SUBJECT: ADDENDUM TO ORNL CF-61-2-46,  
MOLTEN-SALT REACTOR EXPERIMENT  
PRELIMINARY HAZARDS REPORT

ADDENDUM TO ORNL CF-61-2-46,  
MOLTEN-SALT REACTOR EXPERIMENT PRELIMINARY HAZARDS REPORT

Since the "MSRE Preliminary Hazards Report" was written (February 1961), several changes have been made in the MSRE design, and additional information has been requested by the AEC Division of Reactor Development. It is the purpose of this Addendum to up-date and correct the original report and to provide the additional information.

Fig. 18(Rev.). MSRE Plant Layout, Plan.

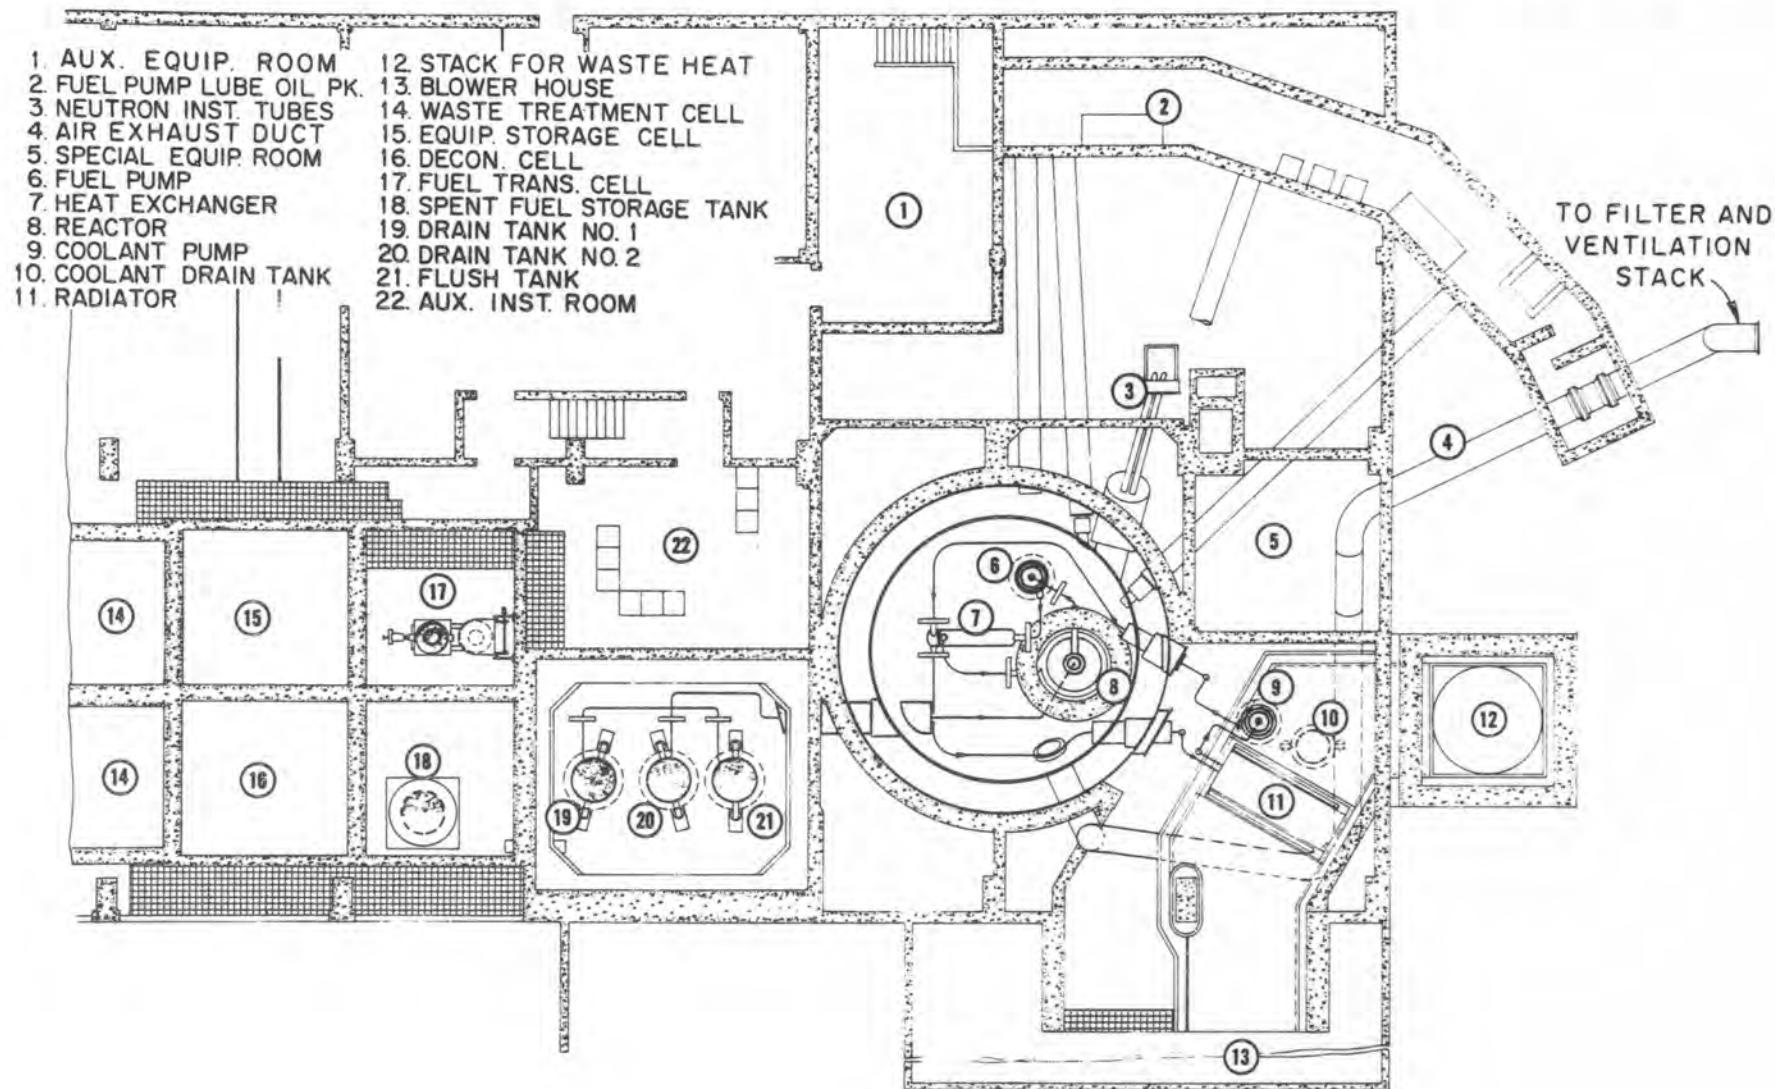
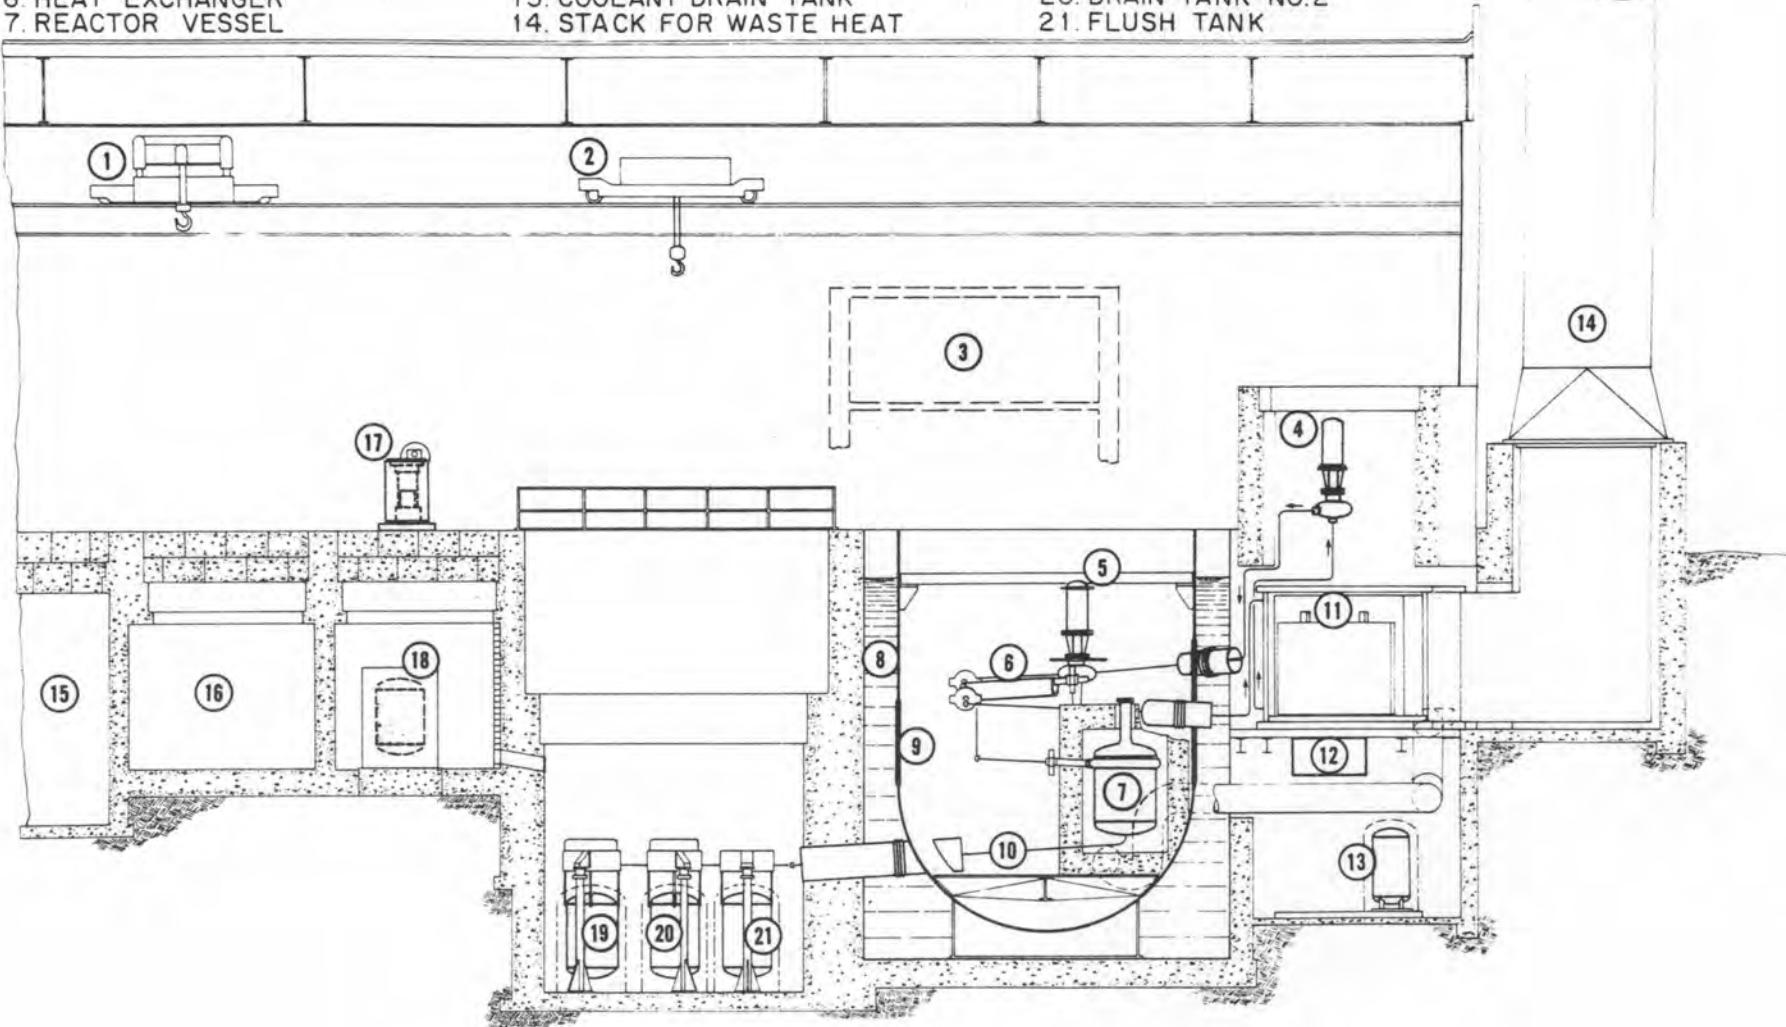
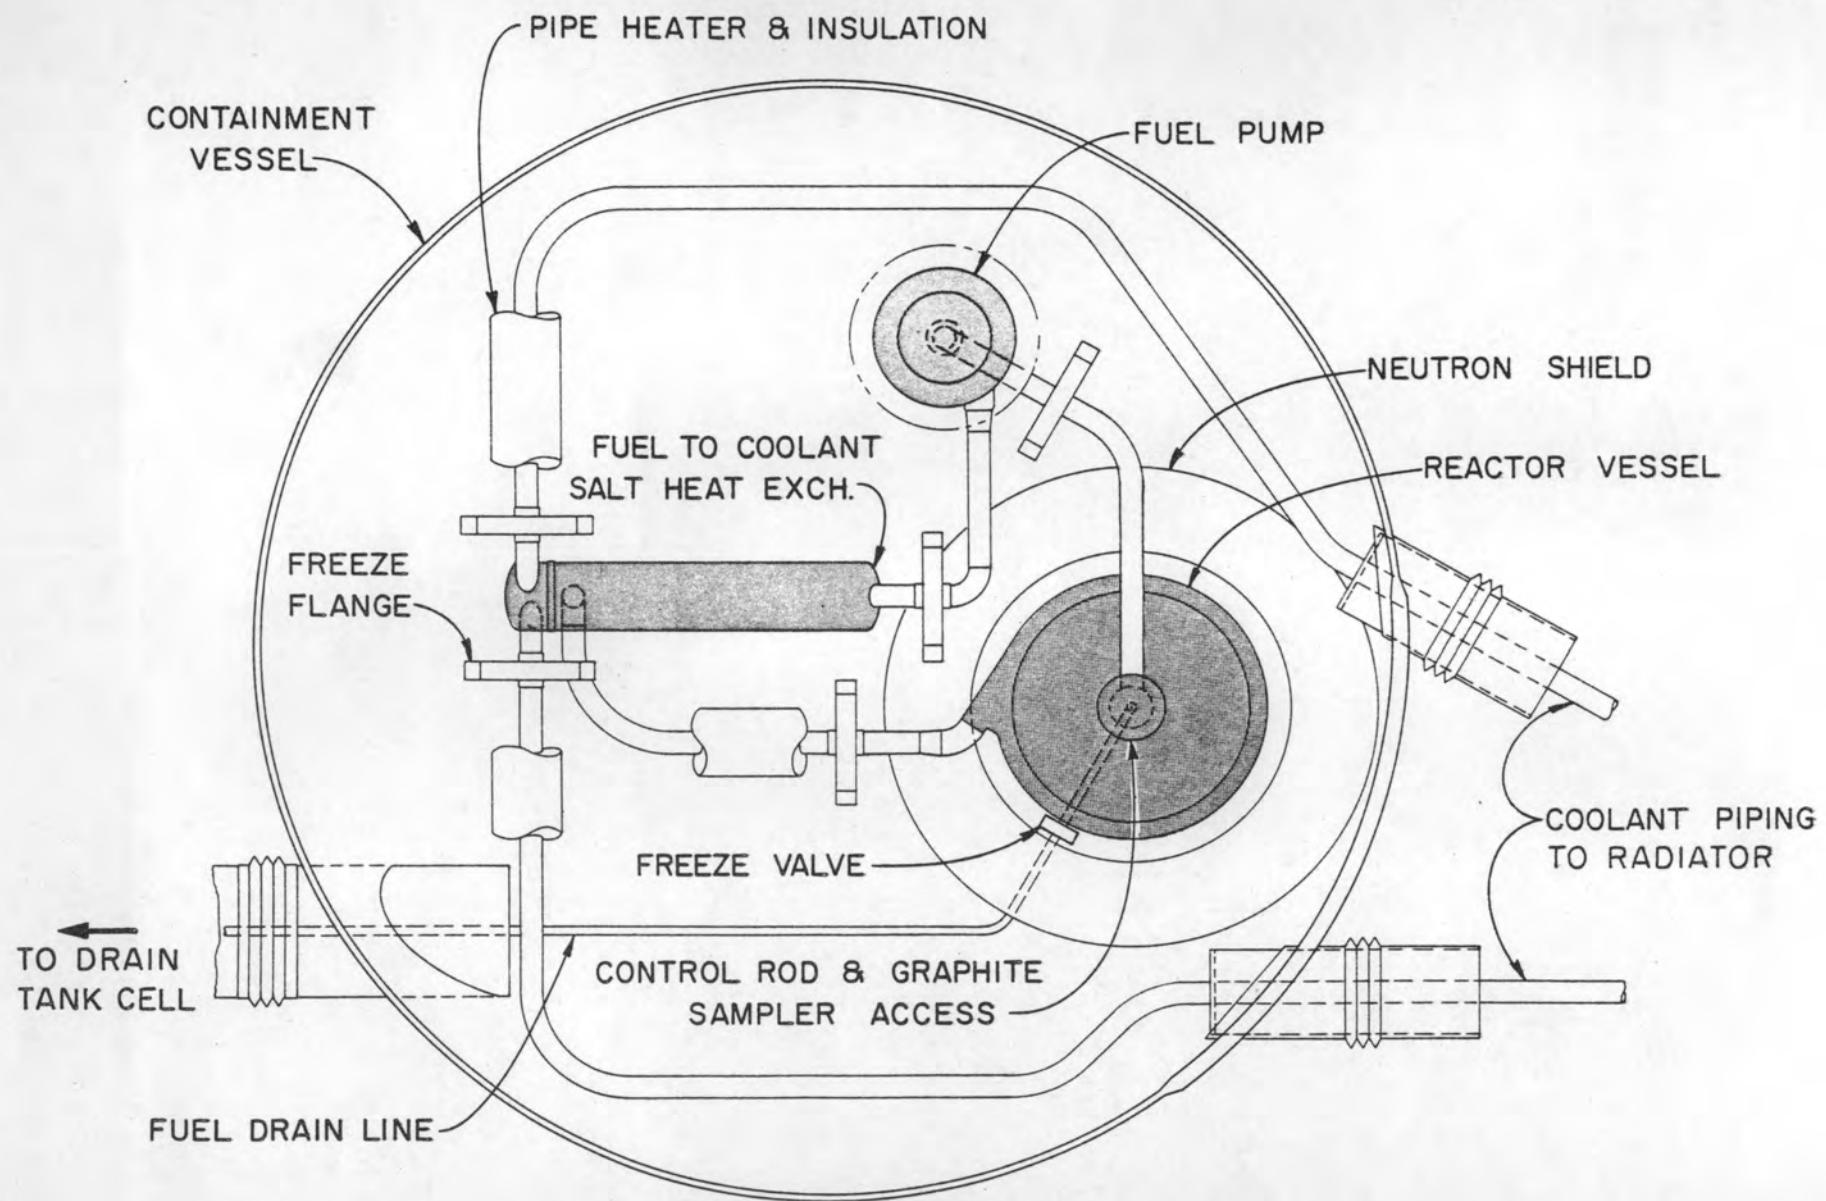
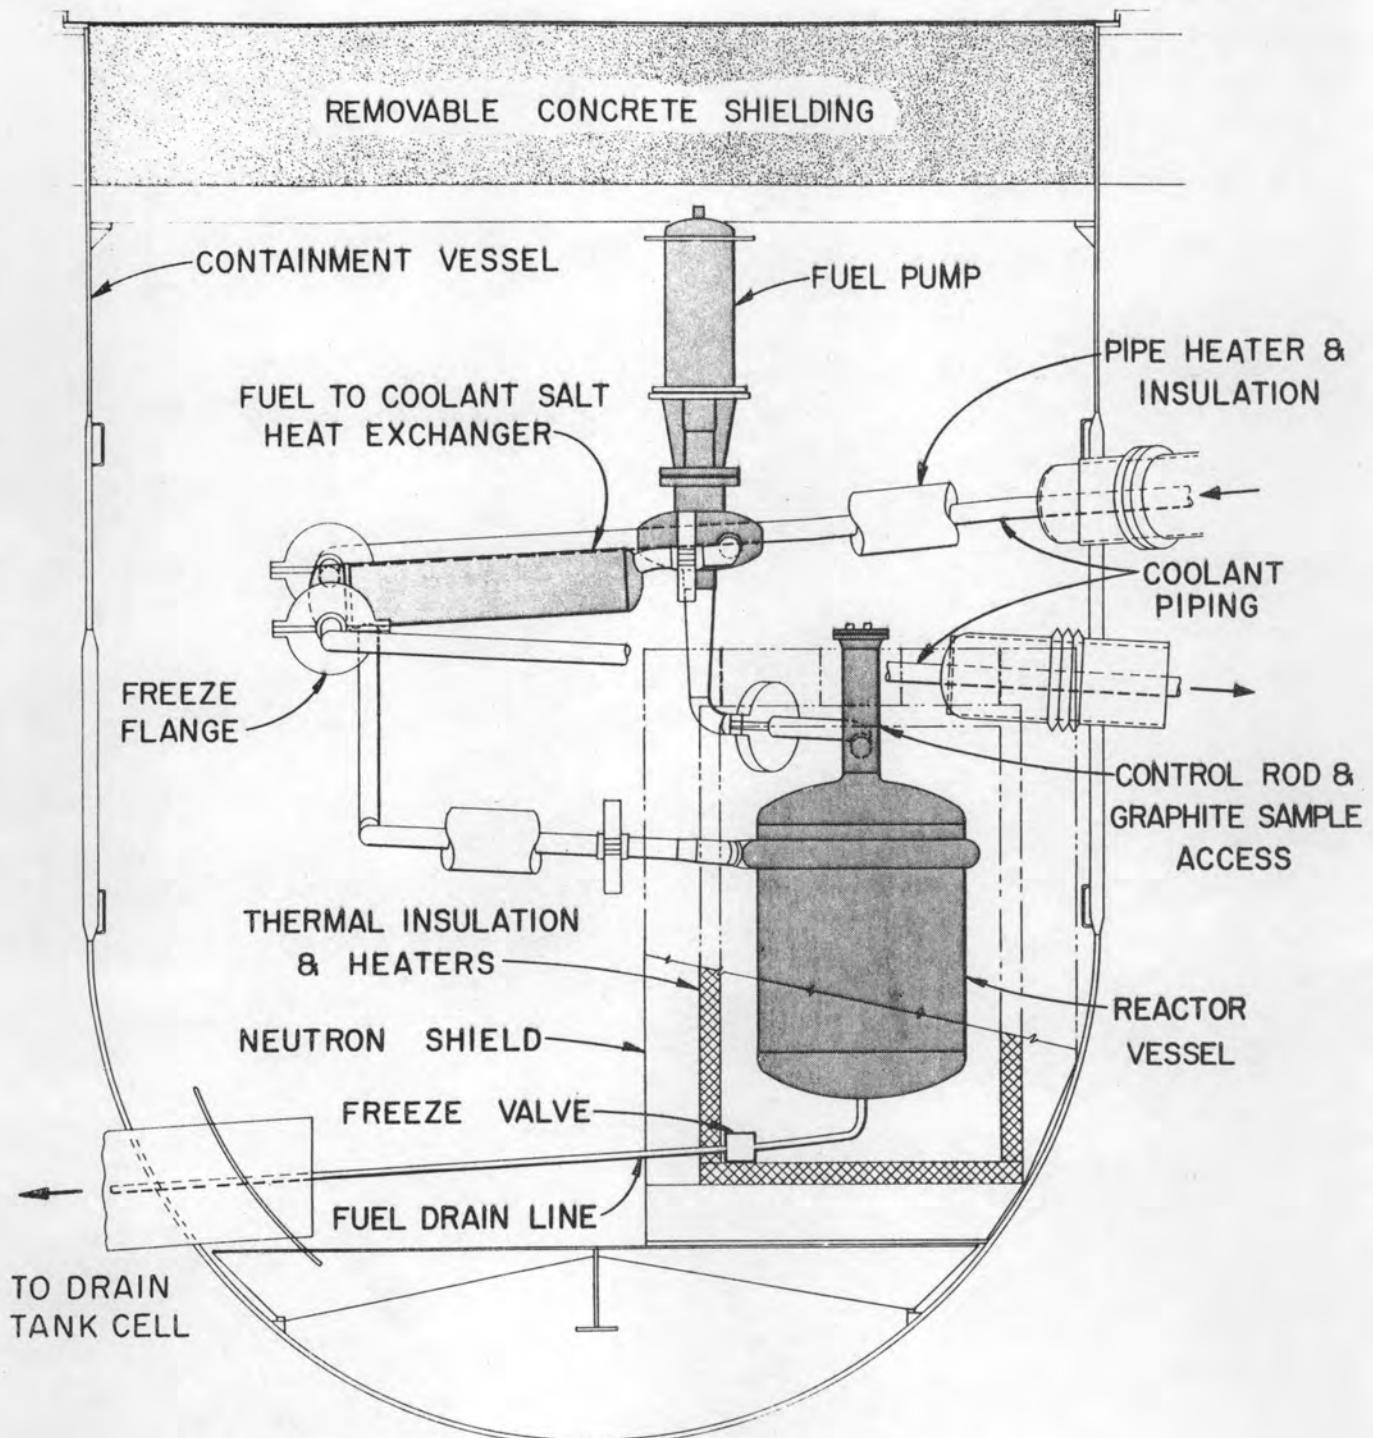
As has already been mentioned, the equipment within the reactor cell has been rearranged, and the piping sizes and wall thicknesses increased. The drain and flush tanks have also been rearranged to give greater accessibility for maintenance. The new version is shown on Figs. 18, 19, 19-A, and 19-B.

Fig. 22A. ORNL Area Map.

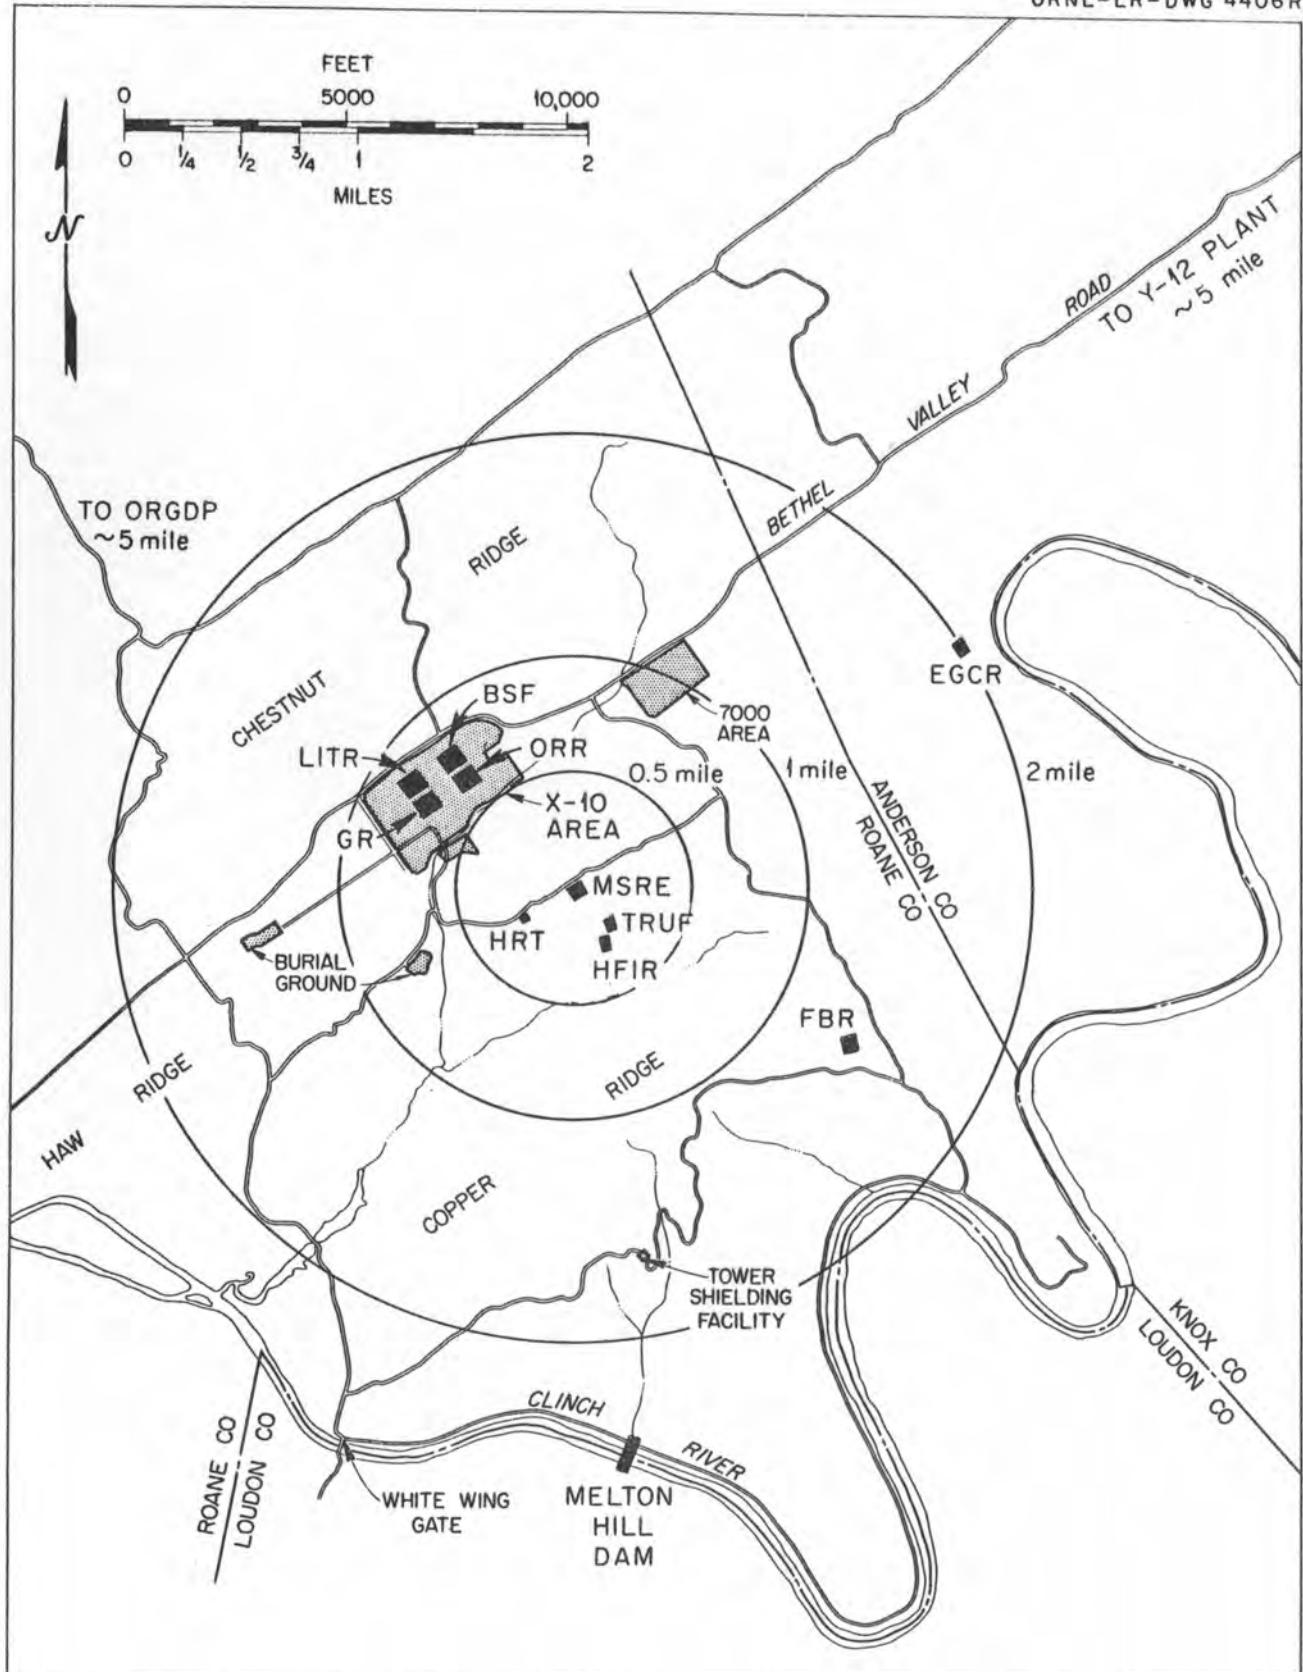
The distance from the MSRE to the HFIR is 1600 ft, and to the EGCR, two miles. Figure 22A shows the relation of the MSRE to all the other reactors in the ORNL area. Within the 0.5-mile radius circle is a population of approximately 200 people. The population within the one-mile circle is 4200. A 110-ft-high ridge intervenes between the MSRE and the X-10 area, where most of the people work. The two-mile-radius circle includes only about 200 more people. As was shown in the calculation of the maximum credible accident, there is no danger of overexposure to the population beyond 0.5 miles. The distribution of this personnel and the population of the surrounding towns and counties are shown in Tables 10, 11, and 12.
